DOCUMENT CHANGE REQUEST

DCR number 317	Changes required for: N/A	Originator: Olivier Masson Chief
Date: 2007/02/01	Date sent: 2007/02/01	Organisation: CNES
Status: IMPLEMENTED

Title:	Contacts Coaxial Crimp-type and Solder-Type for 3401/001 and 3401/002 Connectors		
Number:	3401/004	Issue:	2

ESCC Detail Specification No. 3401/004

FIGURE 2(a) – PHYSICAL DIMENSIONS (CONTINUED)

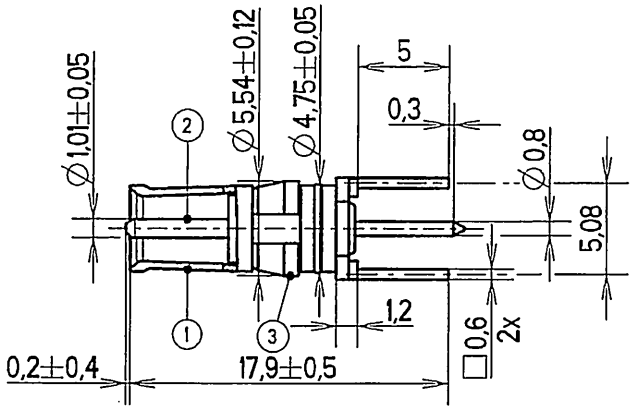
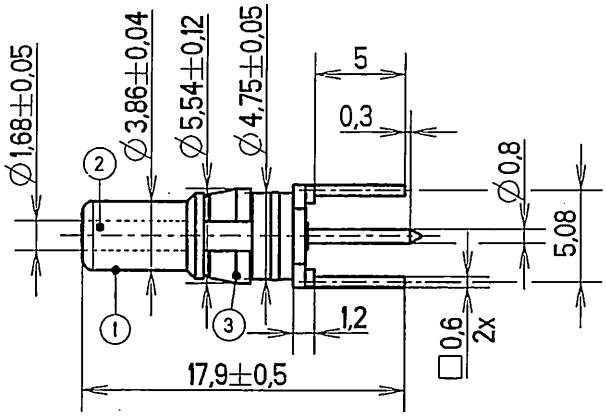
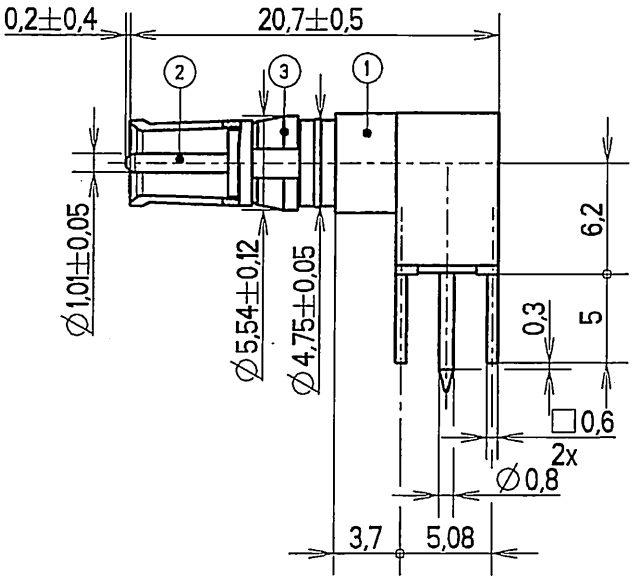
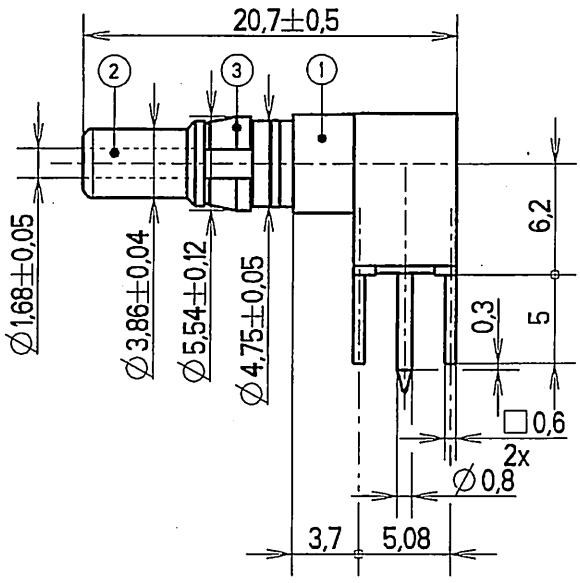
6 - Figure 2, Figures for new variants 21 to 24 added as shown in the attachment.

FIGURE 1 - PARAMETER DERATING INFORMATION

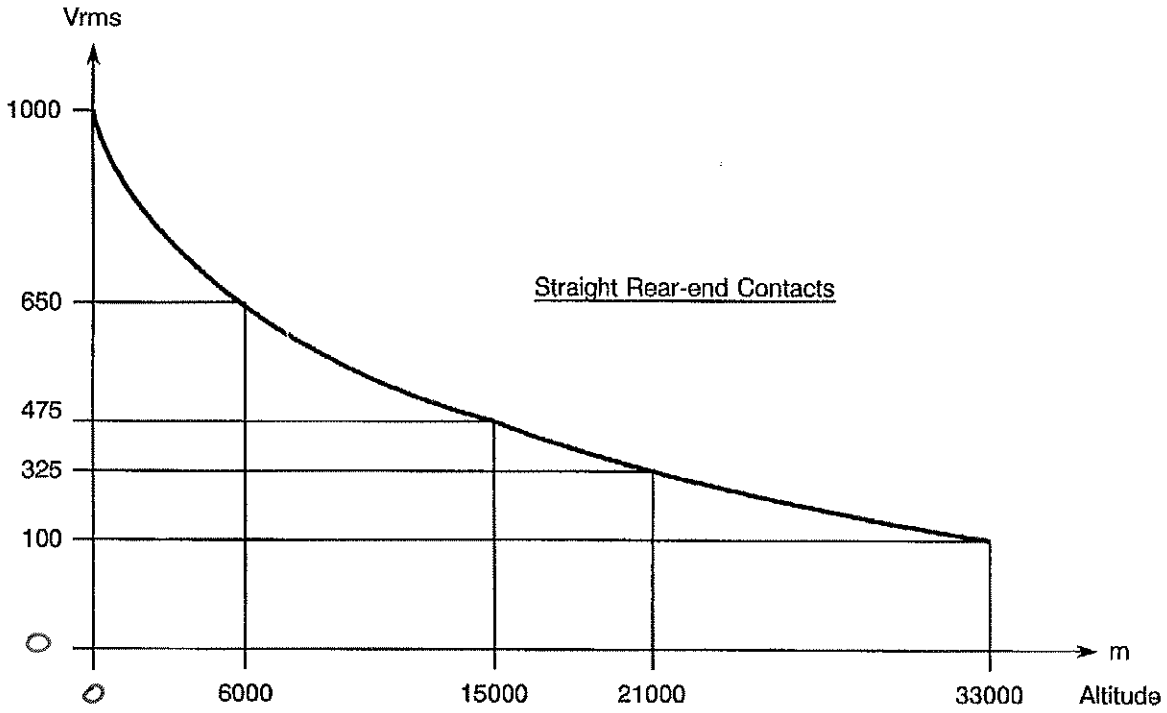
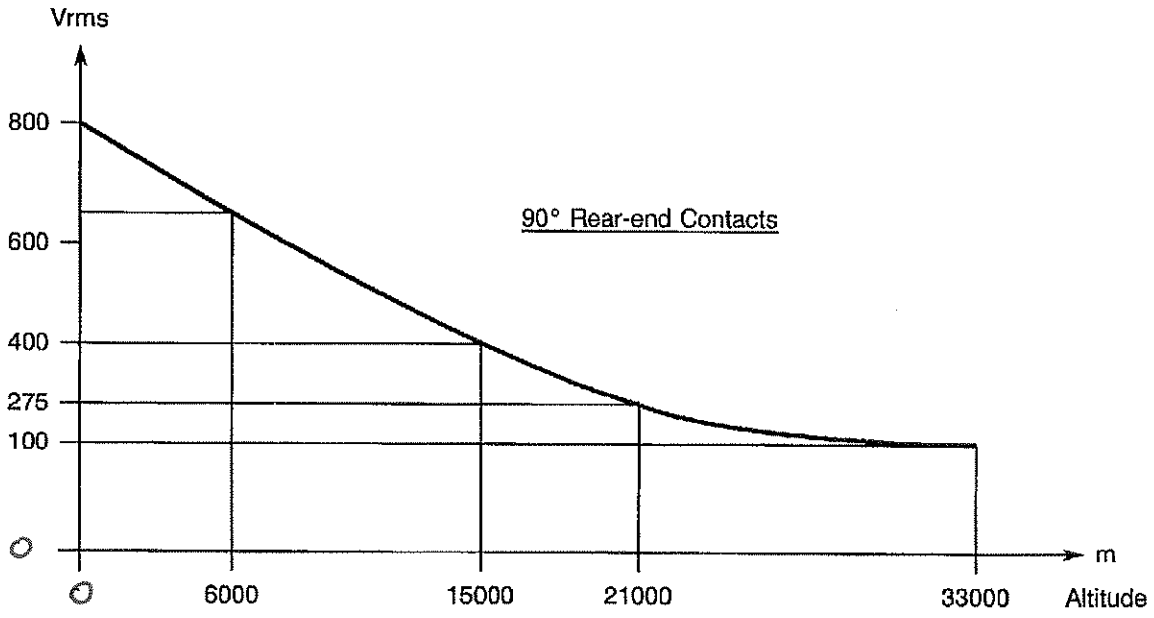
5 - Figure 1, add '0' labels to x & y axes for both figures

FIGURE 2 – PHYSICAL DIMENSIONS (CONTINUED)

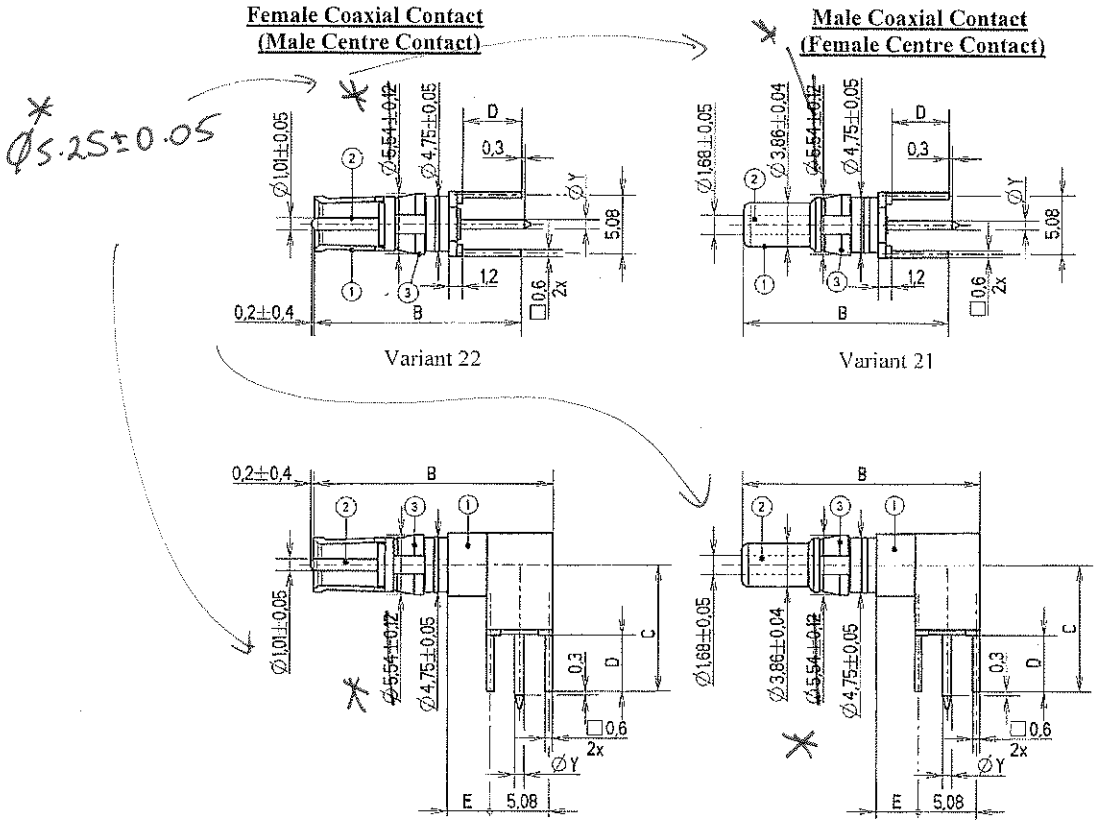
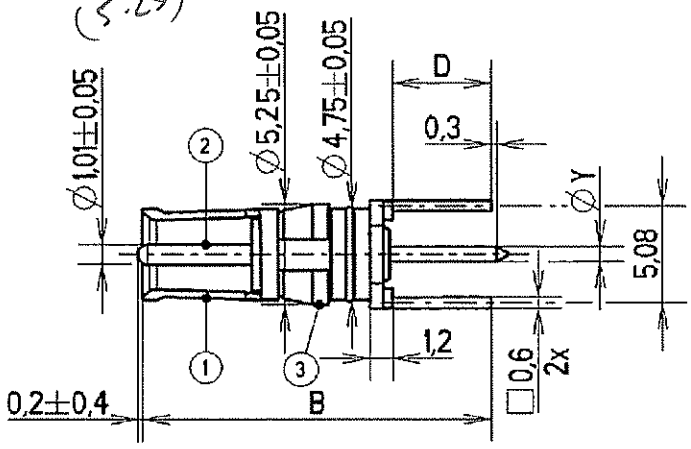
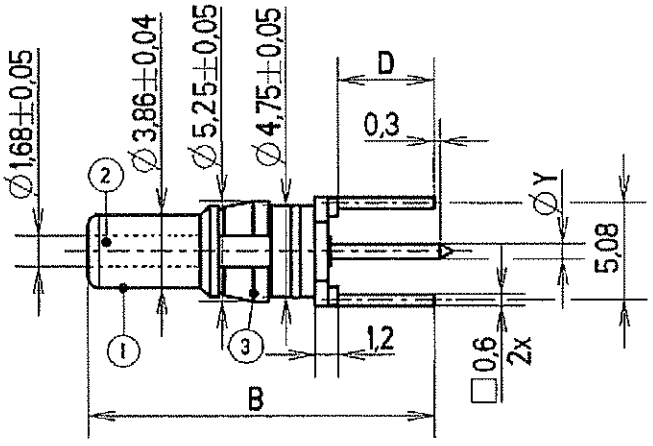
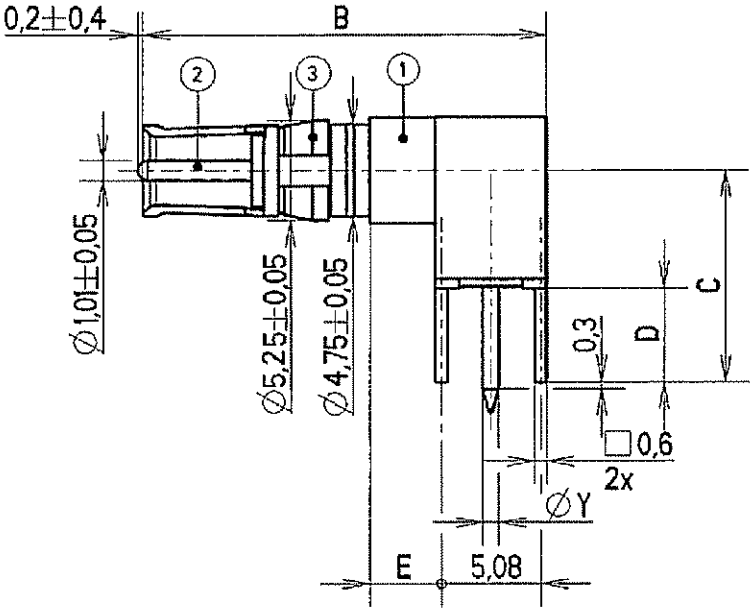
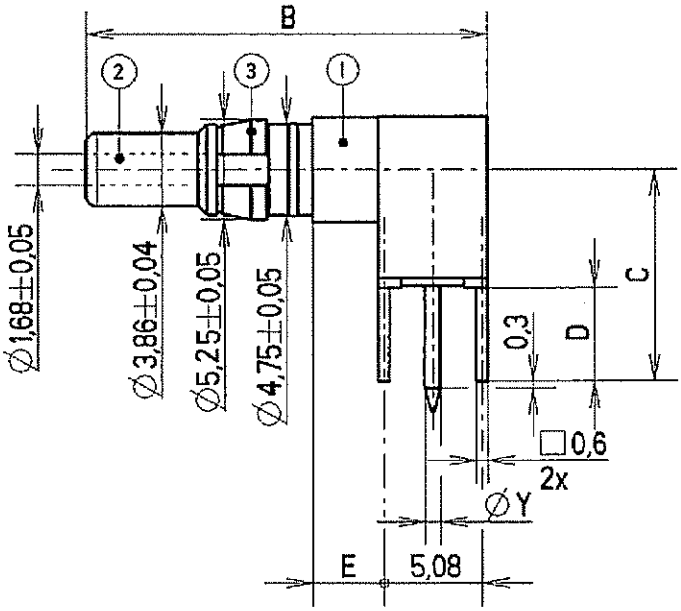
New Page

FIGURE 2 - PHYSICAL DIMENSIONS (CONTINUED)

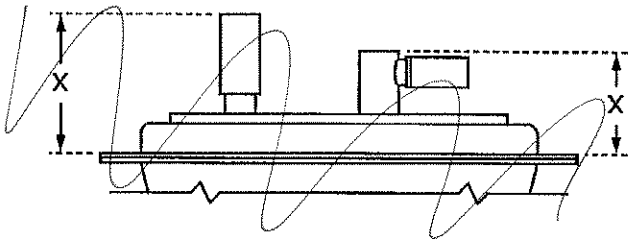
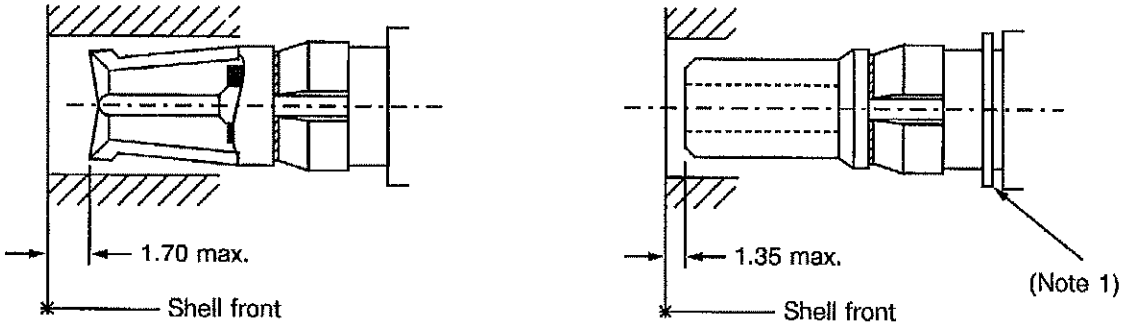
7 - Figure 2 (page 10) Maximum protrusion figure amended as shown in the attachment.

replace by new figure attached.

FIGURE 2 – PHYSICAL DIMENSIONS (CONTINUED)

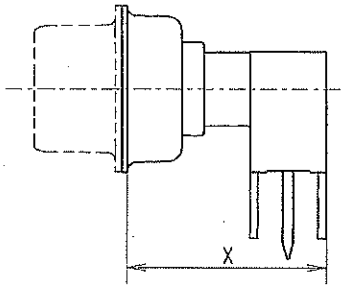
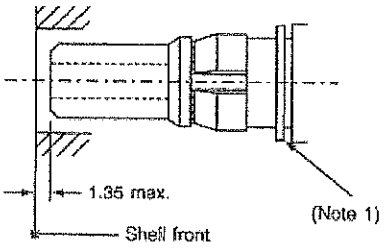
See Page X for value of X. → page 12 ?

Dimensions in millimetres. For lettered dimensions, see table on Page X → page 12 ?
